**SUBMISSIONS AS TO THE IMPACT OF FLOODING, RAINFALL RUN-OFF
AND THE APPLICANT'S FLOOD RISK ASSESSMENT 18.03.2021 (FRA)**

Full Planning Application [P/FUL/2021/01018](#)

Install ground-mounted solar panel photovoltaic solar arrays, substation, inverter and transformer units, security fencing, gates and CCTV; form vehicular access, internal access track, landscaping and other ancillary infrastructure.

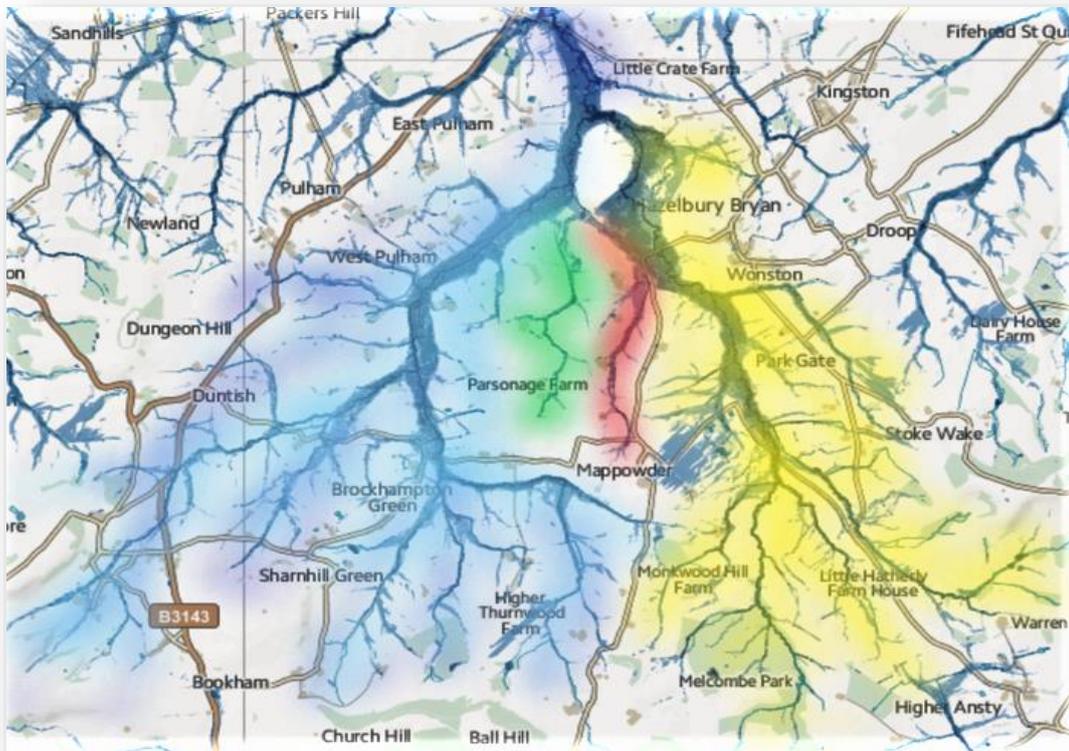
11. Image 1. above (E.A surface flooding map) The Upper River Lydden and its catchment area in blue (24.463 km²). The Wonston Brook and its catchment in yellow (15.013 km²). The central Short Wood Brook watercourse in green (1.45 km²) and the Parsonage Farm Brook watercourse in red (1.0 km²).

12. There are several 'ordinary watercourses' on and around the Site. They include the Short Wood Brook with a catchment area of 1.45 km² which flows through the centre of the Site, and Parsonage Farm Brook, with a catchment area of approximately 1.0 km² which flows along part of the north-eastern Site boundary.

13. Short Wood Brook rises east of Mappowder, crosses (floods) Taylors Lane 74m west of the Pleck Hill Junction. Its catchment area includes Mappowder Cottages and Hammond Street Farm. It runs about 80 metres east of Parsonage Farm and some 165 metres east of Dairy House Farm. It also passes close to Boywood Cottages, Old Boywood Cottage, Povert Bridge Farmhouse, and Old Boywood Farm.

14. Parsonage Farm Brook forms the actual north eastern boundary of fields 6. and 7. of the proposed development. It joins Short Wood Brook between fields 4. and 6. (not as indicated in the Applicant's PFA at a point "near the northern Site boundary" and enters the Upper Lydden some 290m (PFA - refers to an incorrect 155 m) north of the Site.
15. The Upper River Lydden is located approximately 90 m to the west of the Site, at its closest point, and flows in a north-easterly direction. The Upper River Lydden has a catchment area of approximately 24.463 km² (PFA refers to an incorrect area of 20 km²).
